## ***Interactive comment on “Development of a method of robust rain gauge network optimization based on intensity-duration-frequency results” by A. Chebbi et al.***

**A. Chebbi et al.**

Received and published: 5 April 2013

Figure 1. Location of rain gauges in the study area (Medjerda basin *BV5*; Northern coast basins *BV3* and surrounding basins Meliane Basin *BV4*; Central Tunisia basins *BV6*)

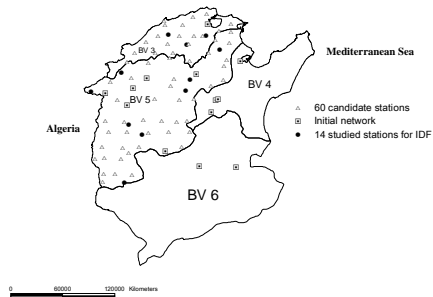
Technical corrections P 14206 line 20 and line 24: 14 is the number of rain gauges for which Data inputs of IDF curves are available (DGRE-ST2i, 2007) while 13 is number of rain gauges of the initial network functioning in March 1973. P 14207: line 8: this reference has been suppressed P14208 line 20: It seems that a point “.” is missing in the editorial document. P14209 Montana has been deleted in the new title. Thank you. P14210 line 9: Yes; thank you P 14210 line 19 Yes; thank you P 14226 Fig. 1 ; it has been corrected
